Justification statement for change in layout

Staffin Harbour Reduced Breakwater Proposal Comparison Plan

Drg. No.	JG5462	Rev: 02	Date: 23.8.2024	Rev: 01	Date: 9.5.2024	Drawn	JG	Chk'd	MH
----------	--------	---------	-----------------	---------	----------------	-------	----	-------	----

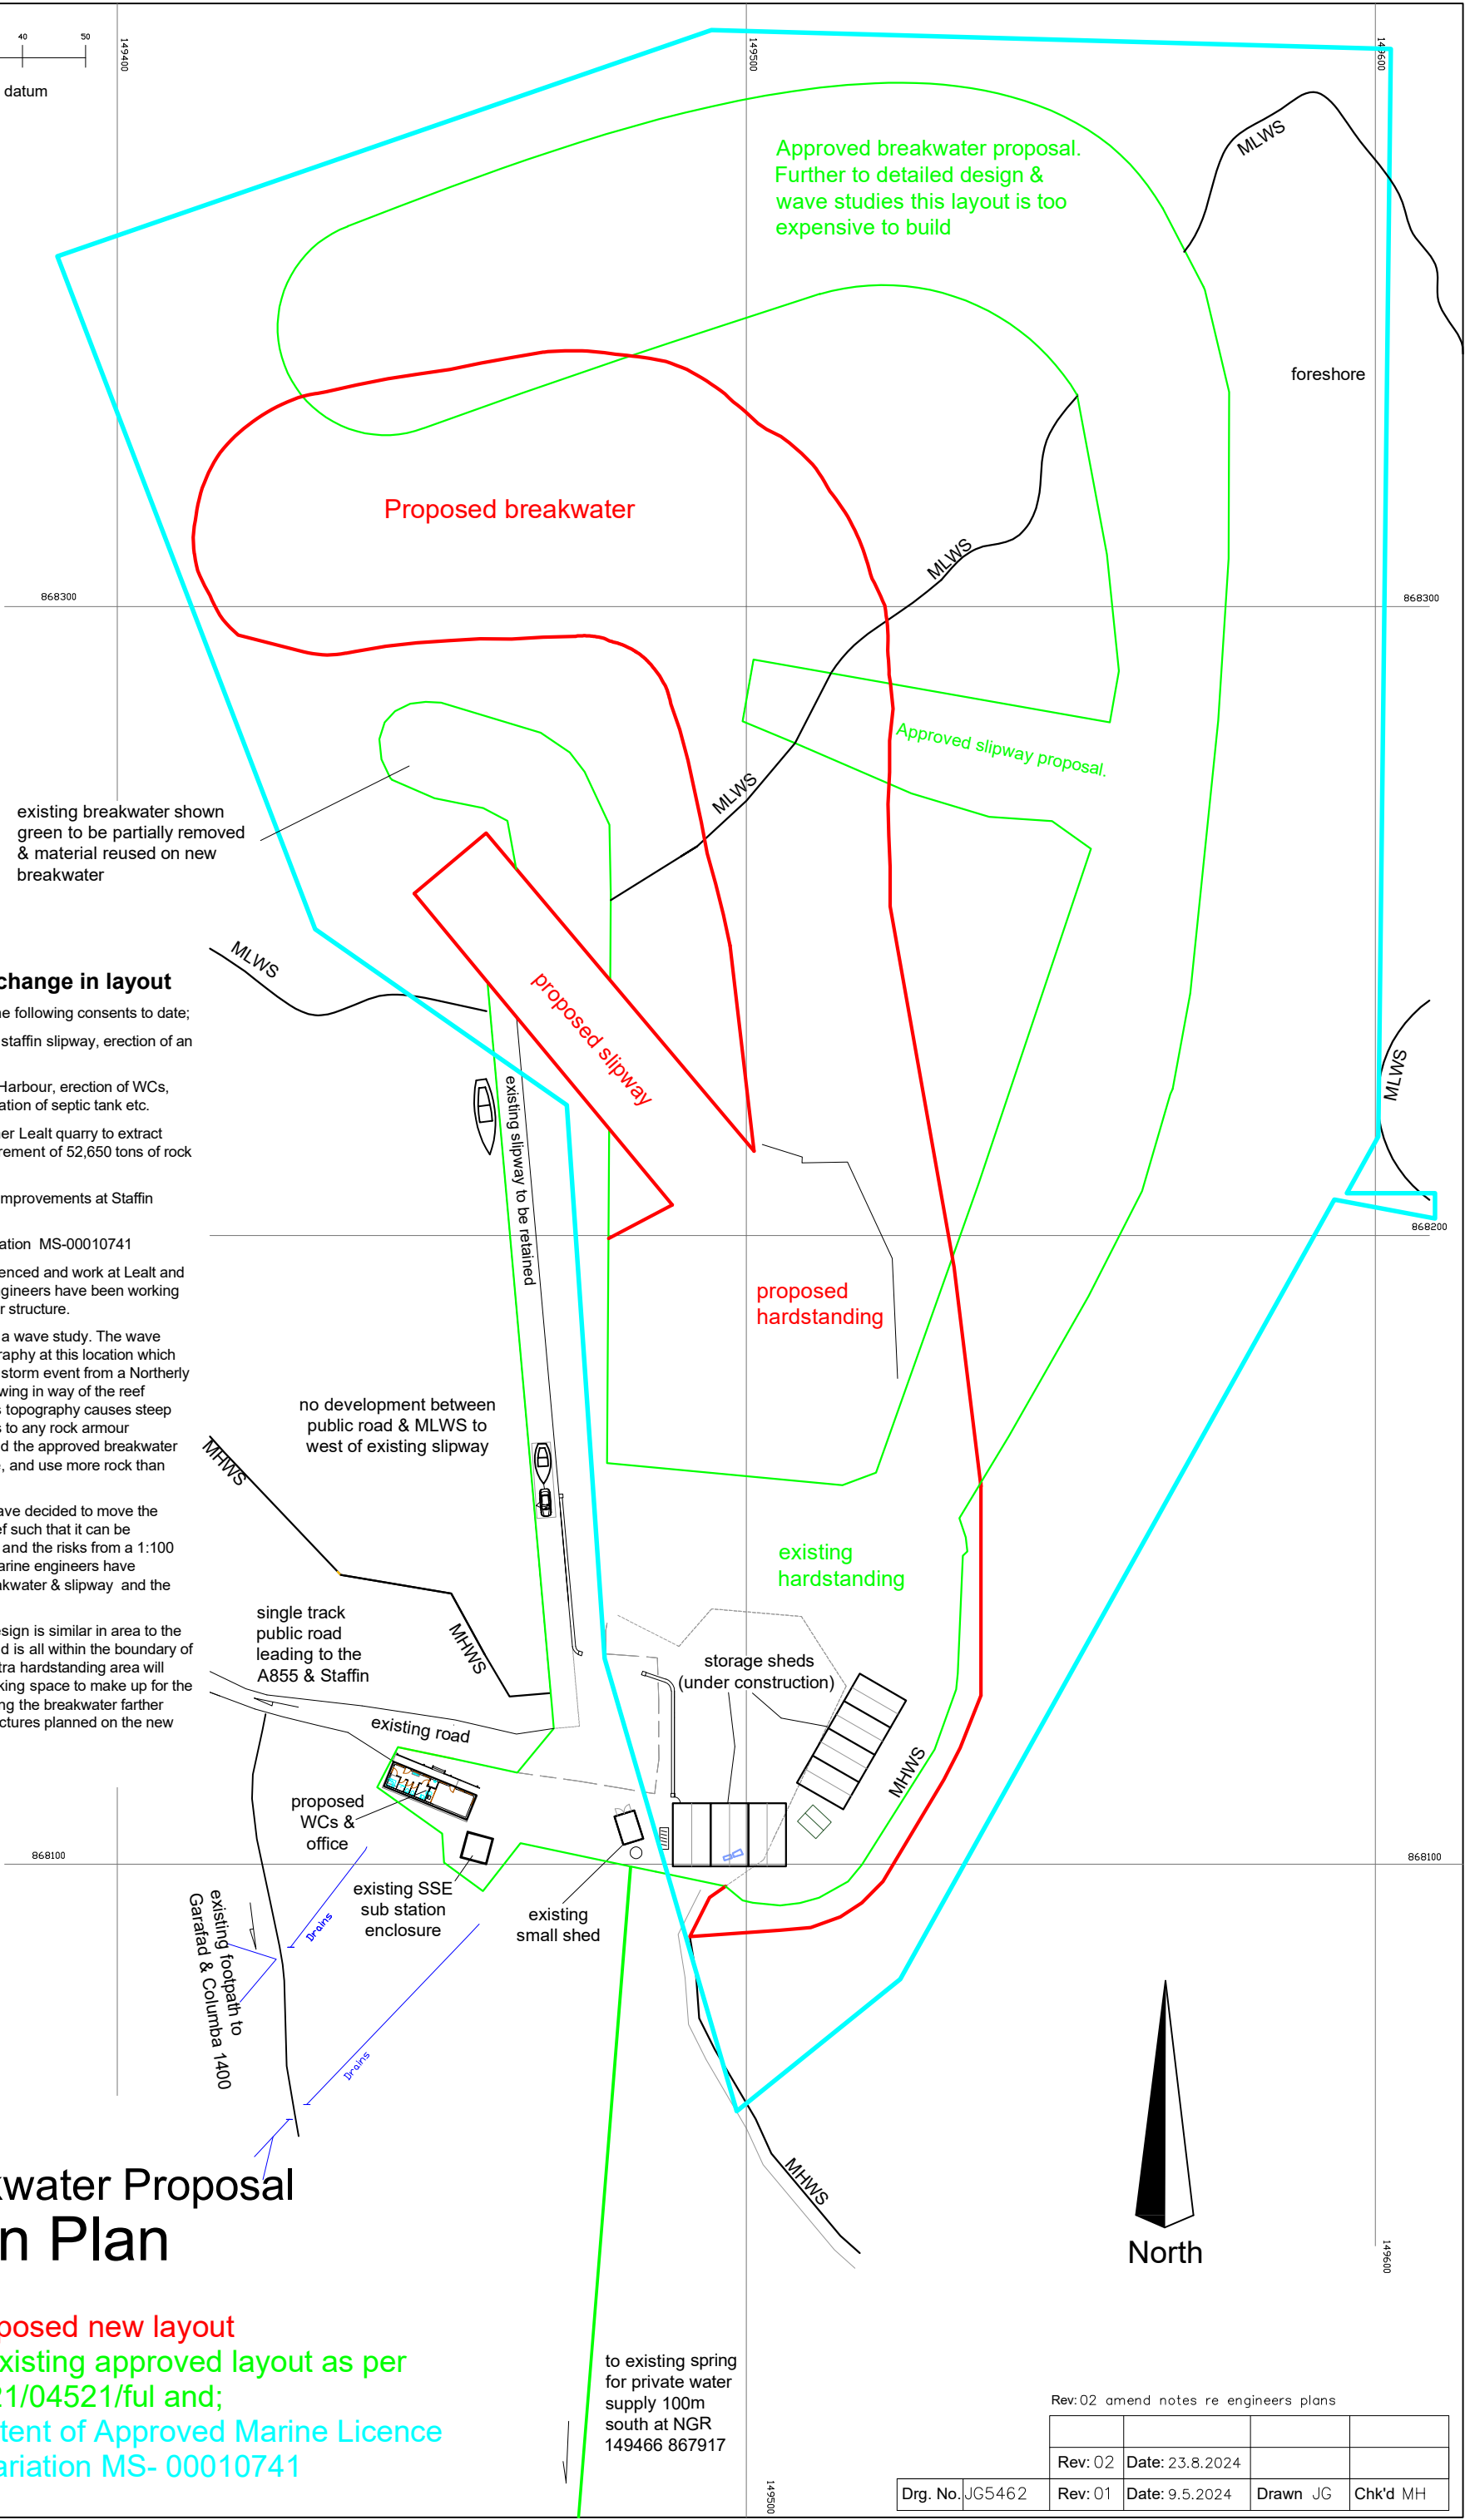
Part of the detailed design process includes a wave study. The wave study highlighted the unusual seabed topography at this location which presents unacceptable risks in a 1:100 year storm event from a Northerly direction, i.e. very deep water quickly shallowing in way of the reef between Staffin Island and the harbour. This topography causes steep breaking waves that are particularly onerous to any rock armour structures built near the reef. As such to build the approved breakwater (green line) would cost more than is feasible, and use more rock than Lealt borrow pit could provide.

Therefore the project team and engineers have decided to move the breakwater west & farther away from the reef such that it can be designed & built using the Lealt rock source and the risks from a 1:100 year Northerly storm are acceptable. The marine engineers have developed a detailed design of the new breakwater & slipway and the new hardstanding area.

The overall footprint & volume of the new design is similar in area to the footprint & volume of the previous design and is all within the boundary of the approved Marine Licence & EIA. The extra hardstanding area will provide more onshore boat, trailer & car parking space to make up for the reduction in pontoon berths caused by moving the breakwater farther inshore. There are no buildings or other structures planned on the new hardstanding area.

Red line indicates proposed new layout

Green line indicates existing approved layout as per planning consent ref 21/04521/ful and;

Cyan line indicates extent of Approved Marine Licence ref MS-00009582 & variation MS- 00010741
